Ted Hunker
Tartan Management
555 Metro Place North, Suite 645
Dublin, OH 43017**Re: Construction Storm Water Inspection at Bedford Landfill**

**Re: Notice of Violation
Commercial Point Middle School / Pickaway County**

Commercial Point Middle School
Scioto River Watershed
February 19, 2009
Photo by: Greg Sanders

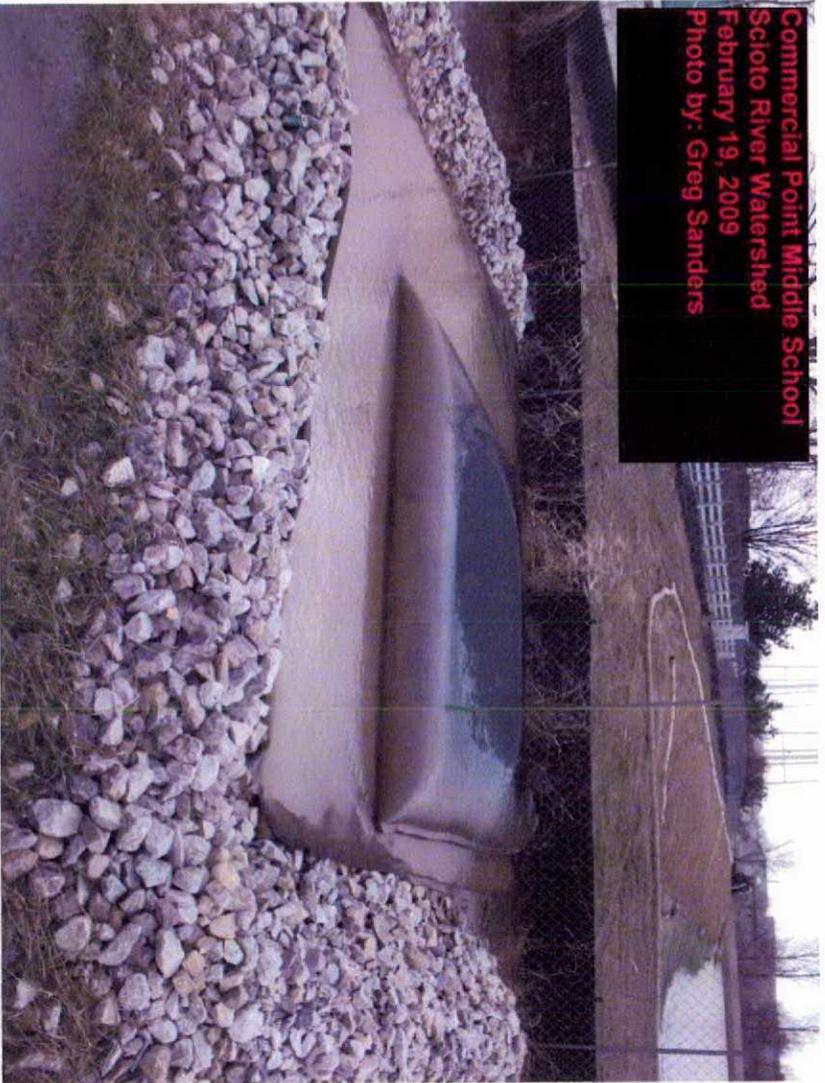
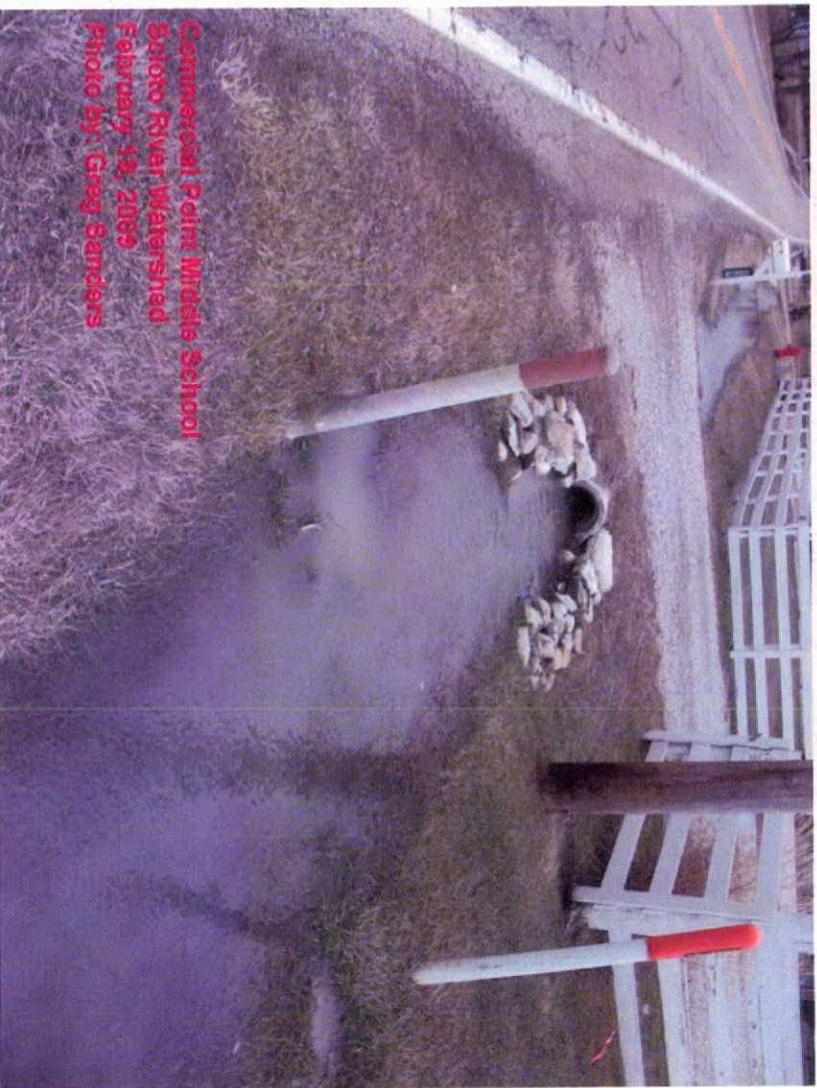
There was a turbid discharge being pumped from the sediment pond located along S.R. 762. There shall be no turbid discharges to waters of the state. It appears that a new filter bag possibly several, need to be installed at the end of the pump discharge. Also, the suction side of the pump should not be placed directly on the bottom of the sediment pond. Please see attached pictures.
